PREPARED FOR THE PLAN COMMISSION

Project Address: 425 West Washington Avenue (District 4 – Ald. Verveer)
Application Type: Conditional Use Alteration
Legistar File ID # [41146](#)
Prepared By: Kevin Firchow AICP, Planning Division
Report Includes Comments from other City Agencies, as noted
Reviewed By: Jay Wendt, Principal Planner

The applicant requests approval of multiple alterations to a completed mixed-use building at 425 West Washington Avenue. This request is subject to the approval standards for Conditional Uses [MGO Section 28.183] and the Downtown Design Standards of 28.07(3) and should also be reviewed against the advisory Downtown Urban Design Guidelines which apply to UMX (Urban Mixed Use) zoned properties.

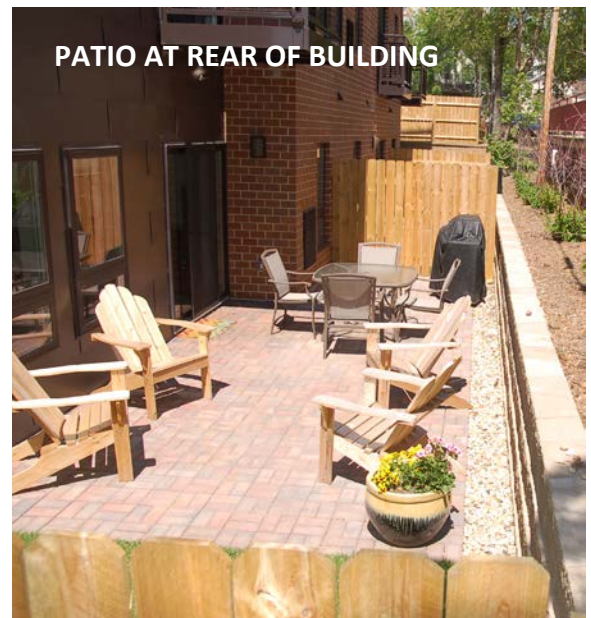
- **Revised Rooftop Screening Fence.** As approved, this fence was intended to consist of dark-bronze metal fencing, which remains preferable to staff. The photo above-left shows the installed condition, which is proposed to be modified. As opposed to installing metal fencing consistent with the original approval, the applicant proposes to modify the installed feature by lowering the height of the wooden lattice work, painting it dark bronze and capping it with a 1.5 inch pipe rail, painted dark bronze. Supplemental exhibits provided by the applicant show that the height of revised exhibit would match the height of the approved detail. The overall visibility of this element will be reduced.

- **Ground Level Screening Fence.** The applicant proposes to modify the existing fence, photo above-right. The lower four feet of the fence will remain wood and a two-foot section of metal lattice, matching the balcony lattice, will be added. They will be painted dark bronze to match similar balcony details on the building. Staff has concerns on how integrated these two materials will ultimately appear.

- **Rear Patio Alterations.** Further analysis is also provided for proposed alteration 3B, which has been noted as an area of concern by some neighborhood residents. At the rear of the property (see right photo), a previously approved landscaped area has been constructed as a hard-scaped patio area for tenants. The area is covered with brick pavers. While this provides a nice tenant amenity, the Zoning Administrator has requested confirmation statistics that the project still can meet the required lot coverage requirements. The Zoning Code requires that lot coverage not exceed 90%. That includes buildings, accessory structures and all paved areas (with the exception of sidewalks no wider than five feet). The lot coverage requirement cannot be waived by the Plan Commission. A condition of approval is recommended that the applicant provides calculations showing code compliance. As noted in the previous staff report, most of this area sits above the subterranean parking garage.
